ADDENDUMS/REVISIONS

PROPOSED FLOORPLAN
 SELF SERVICE FROZEN YOGURT
 2750-C Gallows Road
 Vienna, VA

STATUS	
DATE	02/10/2013
SHEET NO	M 1

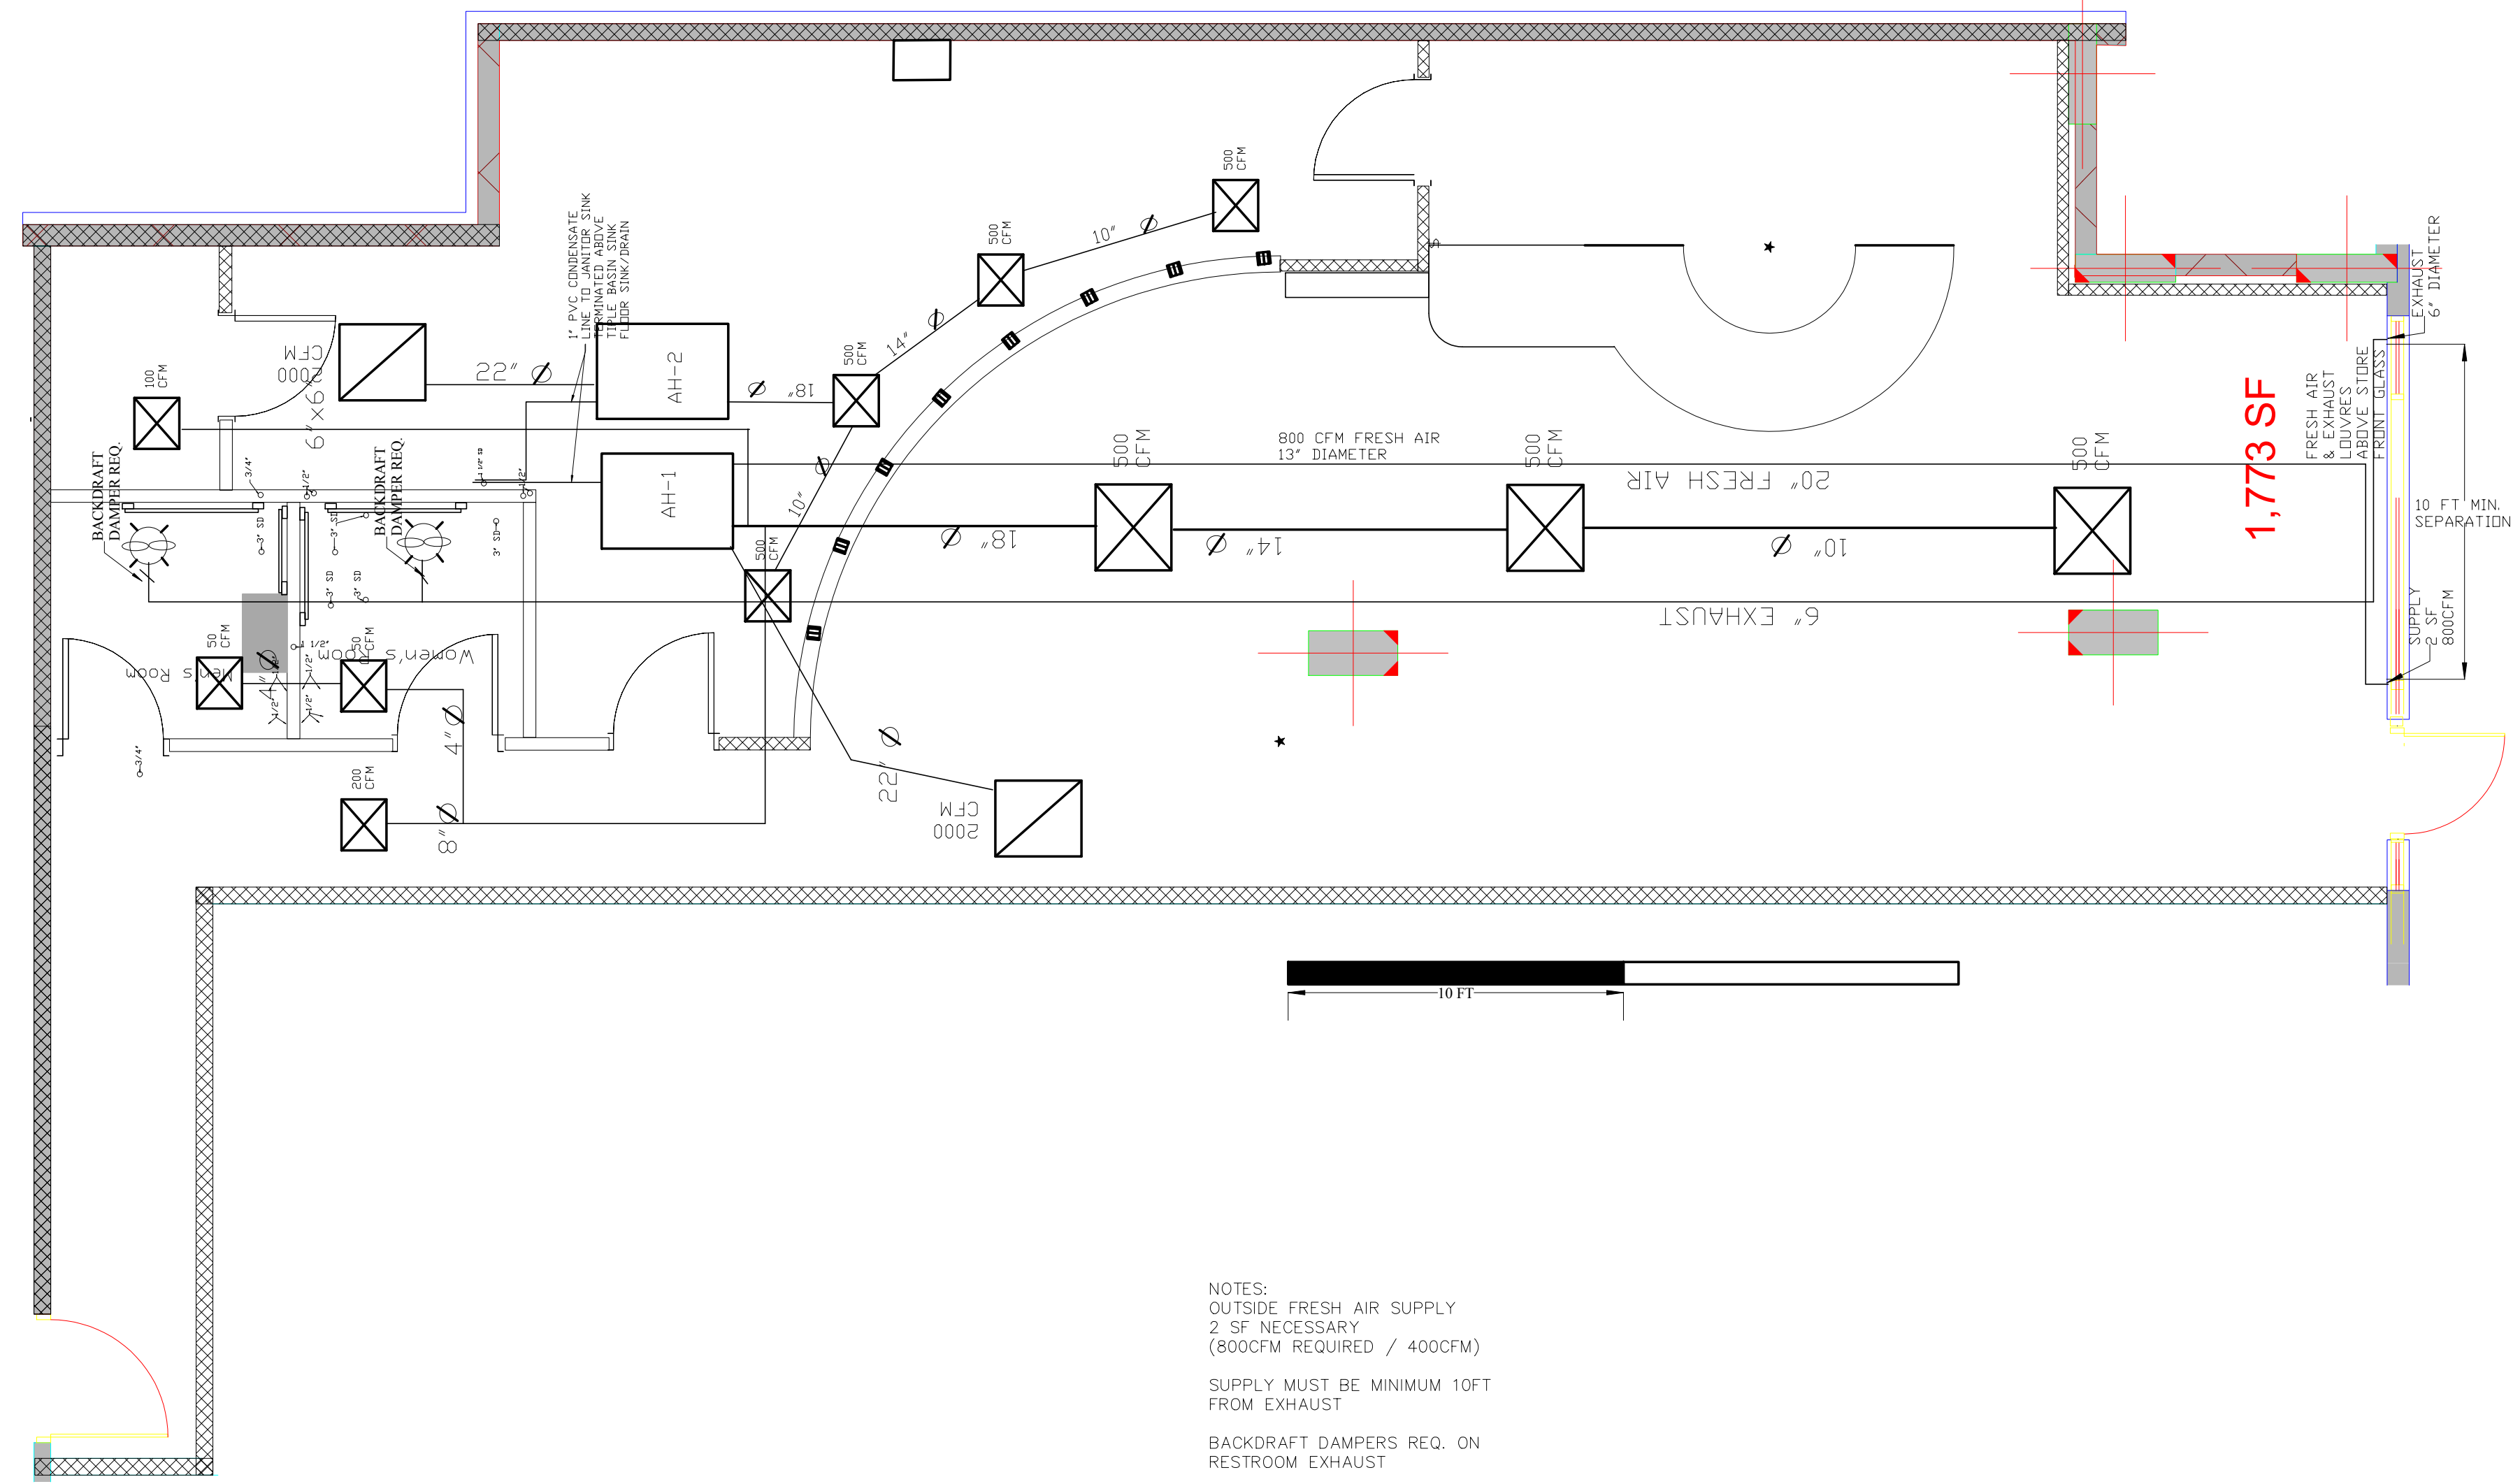
- 2-B-13 RDN ADDED MOUNTING DETAIL FOR AH'S
- PROVIDE CONDENSATION DRAINS FOR AH'S
- MOVED EXHAUST LOCATION FOR RESTROOM EXHAUST
- FRESH AIR CALCULATION RUN WITH SINGLE UNIT
- SUPPLY MOVED FROM CORRIDOR
